APPLICATION NUMBER 76-L-071

STAFF REPORT

GENERAL DEVELOPMENT PLAN

LAKE d'EVEREUX

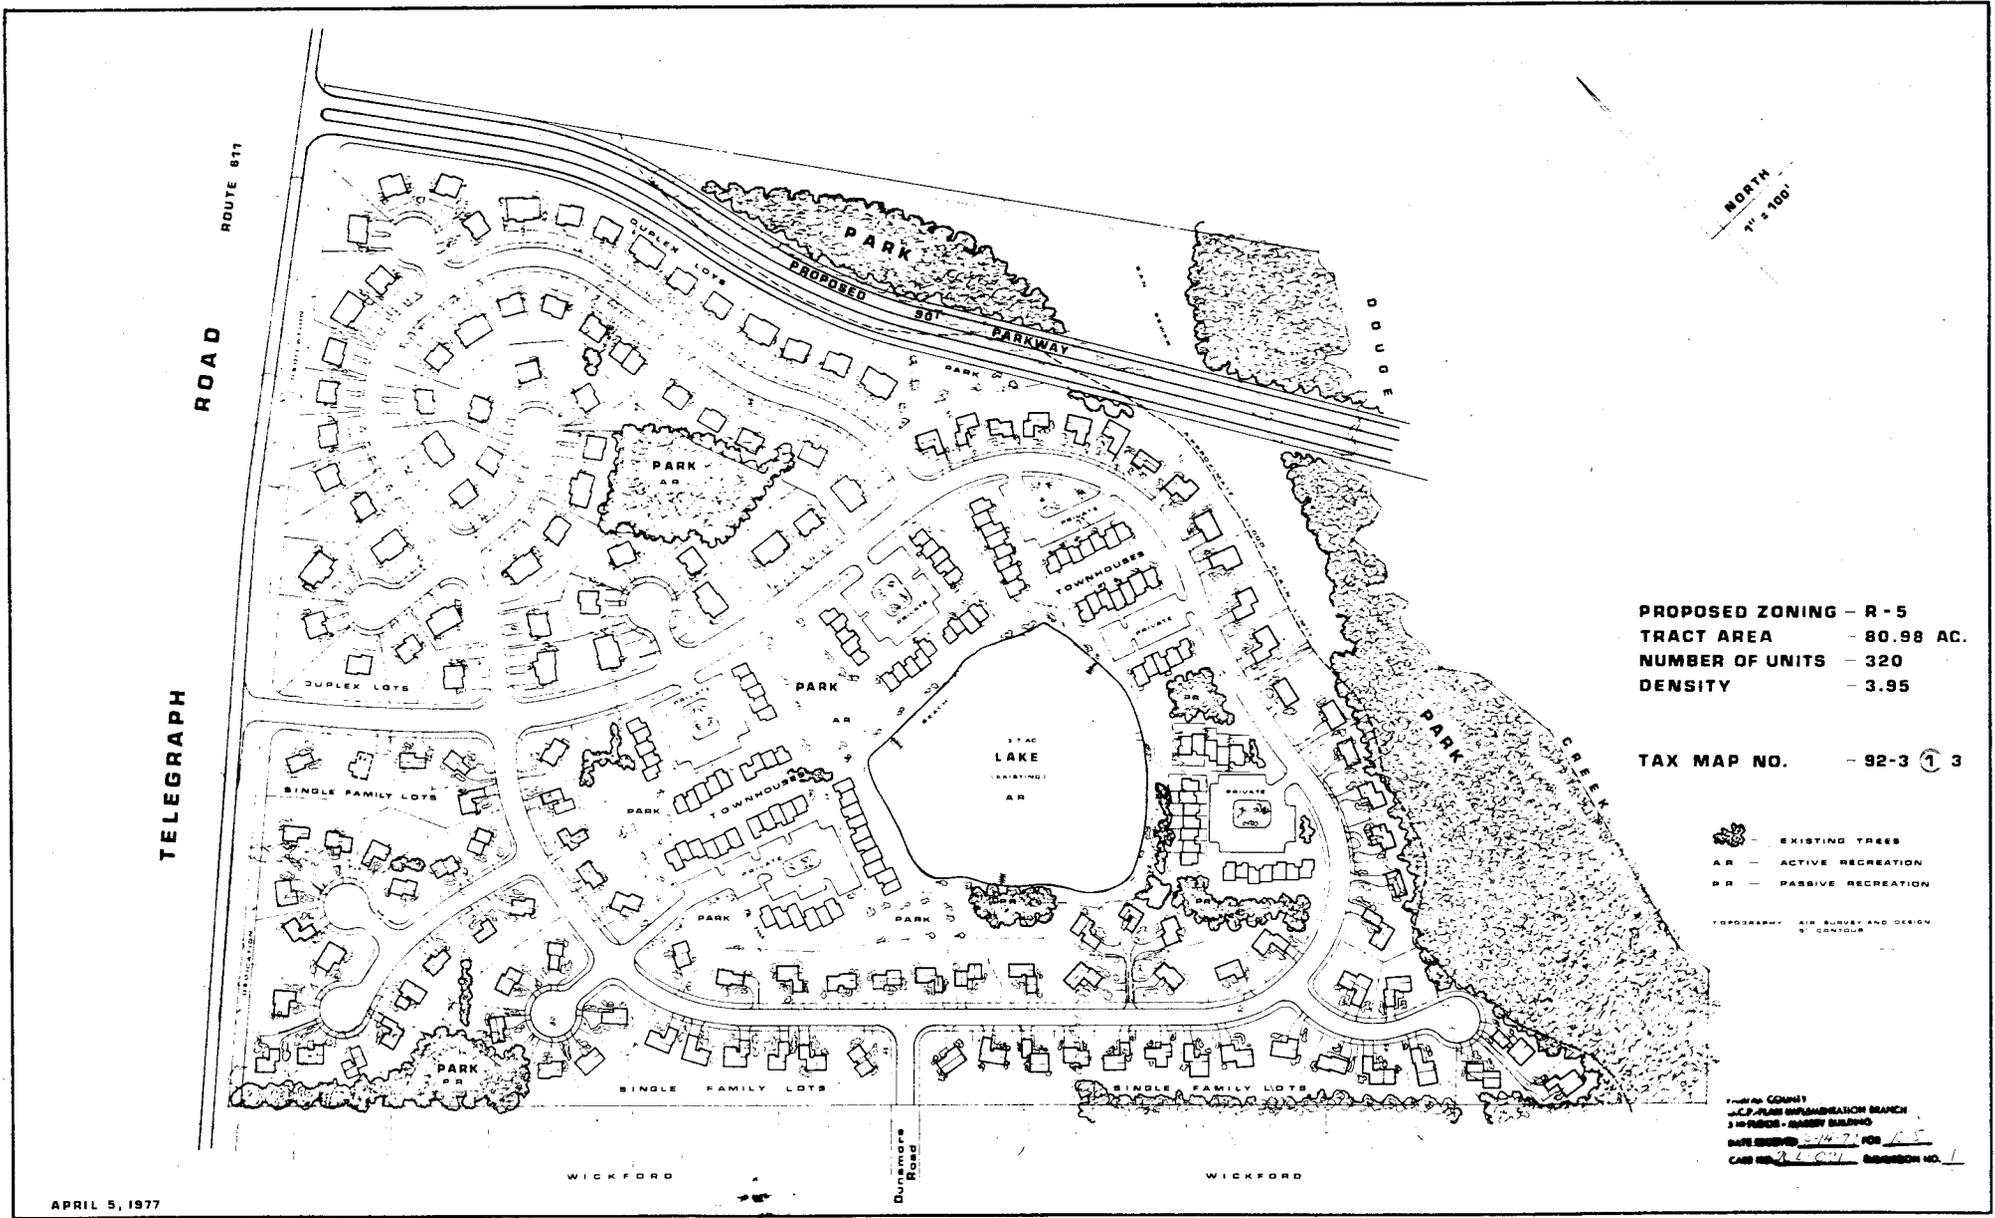
The Conceptual Development Plan shows 91 single family detached, 118 duplexes, and 111 townhouses on this 80.982 acre parcel, a density of 3.95 dwelling units per acre. This is a basically well designed plan which appears to meet the requirements of the R-5 District. Major concerns with the plan relate to the accommodation of the traffic generated within an improved area highway system and environmental safeguards both on and off-site.

Transportation. As noted earlier, the Countywide plan provides for Telegraph Road in this area to be improved to a four lane divided highway. Dedication and construction of road widening along the Telegraph Road frontage would contribute to this improvement and would be consistent with the improvements made in conjunction with other new subdivisions along this route. The construction of road widening would eliminate an interim requirement for construction of a right turn deceleration lane and a left turn lane along Telegraph Road. In view of the proposed alignment of Lockheed Boulevard extension, the staff concurs with provision of a single access from the proposed subdivision to Telegraph Road.

The dedication of the right-of-way for Lockheed Boulevard as shown on the development plan is essential to the ultimate construction of this segment of an improved cross-county highway network. Some adjustment in the alignment, particularly the southeastern end near Huntley Meadows Park is necessary and can be accomplished in conjunction with the Final Development Plan approval.

With regard to the interior street system, estimated traffic counts will be required by Department of Environmental Management so that street widths and cross-section might be determined. Again this can be accomplished later. The street connection to Dunsmore

Road is desirable for internal street circulation and for fire and rescue service alternate access and should be retained.

1. It is recommended that the access point to Telegraph Road be moved west approximately 200'. This is a location with a better sight distance value which also can utilize the existing hedgerow for a wooded entrance to the project.

2. It is recommended that a cul-de-sac be employed to serve the single family lots south and west of the lake and that a natural woodland break be retained between these units and the townhouses to the east of the lake. Also, the woodlands break can serve as a route for emergency overflow at the lake. The lake is at elevation of 60' and adjacent land to the south lies between 45 and 55'.

3. It is recommended that the access from the Dunsmore Road connection into the townhouse portion of the site immediately north of the lake utilize the subtle ridge-line for an alignment. This will allow more units a better focus onto the lake.

4. It is recommended that a cul-de-sac be employed to serve the townhouses east and south of the lake and that no connection be made to the single family detached units adjacent to Wickford.

5. It is recommended that the poor vegetation area north and east of the lake which is proposed for park be used instead as a courtyard, parking and townhouse unit cluster with the high quality oaks and maples retained to the north as a design amenity.

The staff recommends approval of the development plan as a Conceptual Development Plan subject to modifications necessary to incorporate the following listed conditions in preparation of a Final Development Plan.

- o On Telegraph Road (Rt.611) dedicate right-of-way to 45 feet from centerline and construct road widening to 35 feet from centerline with curb, gutter and sidewalk.
- o For Lockheed Boulevard Extended dedicate a 90-foot wide right-of-way through the site essentially as shown on the submitted development plan except the southeastern end of this right-of-way should be realigned to curve eastward.

Traffic Circulation: Agree to consider in preparing the Final Development Plan, the traffic circulation suggestions contained in the preceding Design Considerations section.

CROSS SECTION A-A'

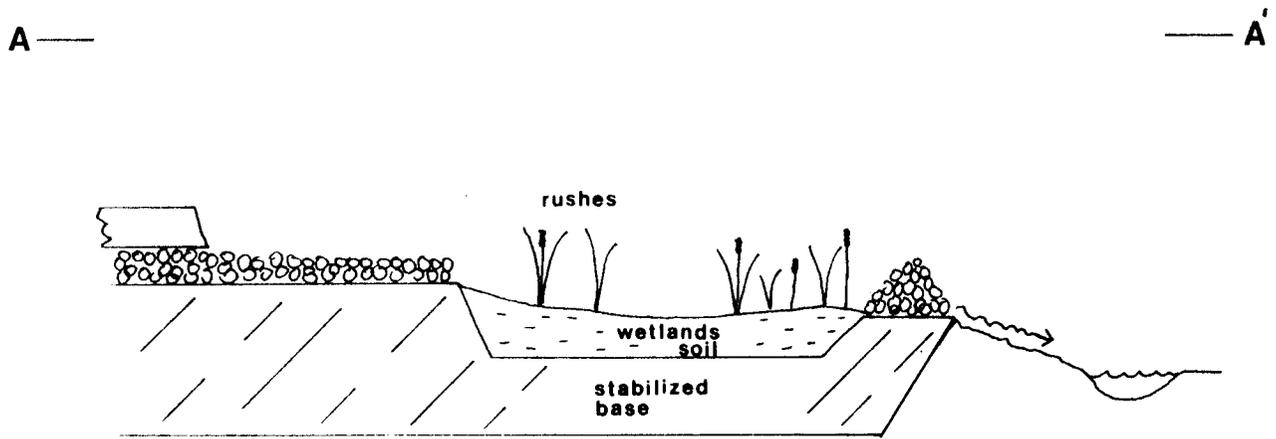
These specimen resources, as well as less spectacular but still useful hedgerow maples and sweet gums should be retained in the project design as an amenity and focal point for the units. Conversely, lesser quality scrub maples, brushy areas or open fields should be used for more intensive unit placement, parking lots and roads.

Preservation efforts for the quality trees must be cognizant of their preferential water environment. Pin oak, maples and willow oaks, especially mature monarchs, will be very intolerant of ditching and filling in their immediate locale. For certain, any of these monarchs will require a construction free zone at least equivalent to the drip line for a particular tree.

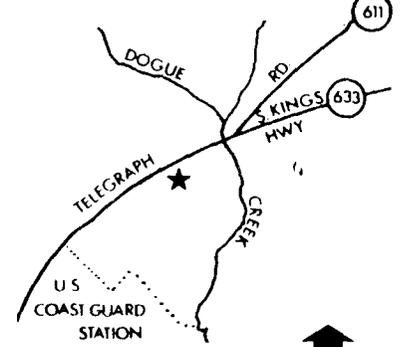
At the proposed Dogue Creek Parkway intersection, this berm should join another berm roughly parallel to the Parkway (berm not proposed for construction until final Parkway grade data becomes available). An area approximately 45' from the edge of the Dogue Creek Parkway right-of-way should be set aside to allow for the construction of a noise facility of up to 10' in height above the level of pavement. This facility will reduce noise levels behind it from 76 dB(A) L₁₀ to 66 dB(A) L₁₀.

The Telegraph Road noise mitigation structure berm should be designed to attenuate primarily automobile noise. (Relatively few trucks with high exhaust stacks). The berm design should seek a reduction of between 5 and 8 decibels. Consequently, the facility should be approximately 30-32' wide at the base and approximately 7' high relative to the elevation of the pavement on Telegraph Road. (2:1 side slopes, 3-4' top width). The Telegraph Road side should be planted to a maintenance free ground cover and landscaped with flowering trees to soften its appearance and enhance the entrance to this development. The project side might be used by adjacent home owners for yard area. If this occurs however, their side must be terraced or walled so that flat useable ground exists in proximity to the homes. (See suggested cross section).

- o Commit to construction of a noise abatement barrier along Telegraph Road of dimensions necessary to achieve a noise reduction of approximately 8 dB(A).
- o Dedicate 45 feet from the southern right-of-way of the Lockheed Boulevard extension for the purpose of accommodating a future noise berm.
